Product / Process Change Notification (PCN)

PCN #: PCN_UtRJ45LAN_20230606
Affected Series: WE-UtRJ45LAN-Series; 7499021125
PCN Date: March 06, 2023
Effective Date: June 06, 2023

Detail of Change:

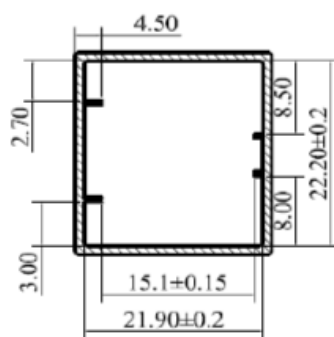
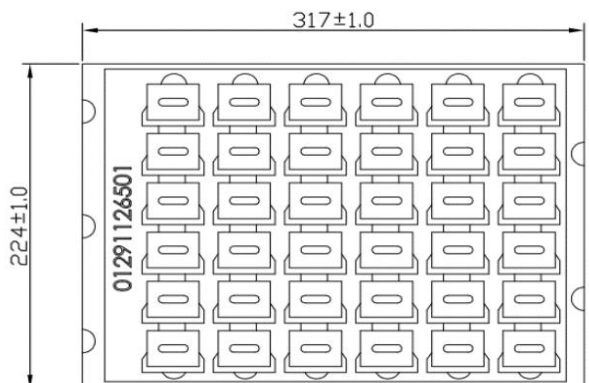
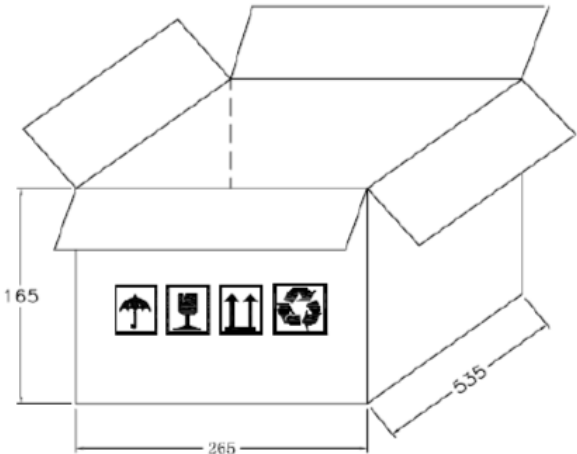
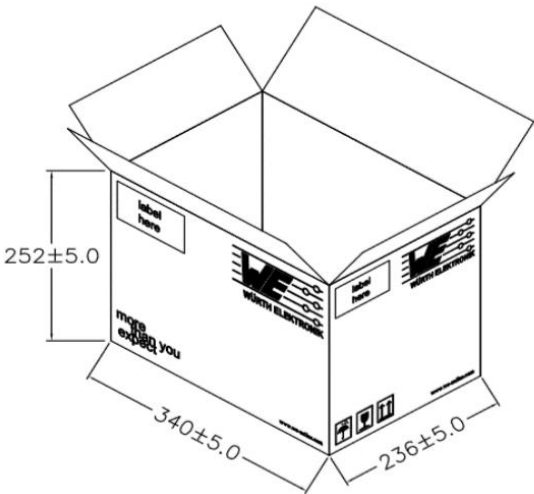
Because of a database mismatch, Würth Elektronik will correct the data sheet.

This is a datasheet correction only. There will be no change in form, fit, function, quality or reliability of the product.

before	after
Tube:  Profile view	Tray:

Top view	
Carton: 	Carton: 
Packing Quantity: tube= 15pcs carton= 900pcs	Packing Quantity: tray= 36 pcs carton= 360 pcs
Reliability / Qualification Summary: There will be no change of the product, therefore no additional reliability or qualification testing will be performed.
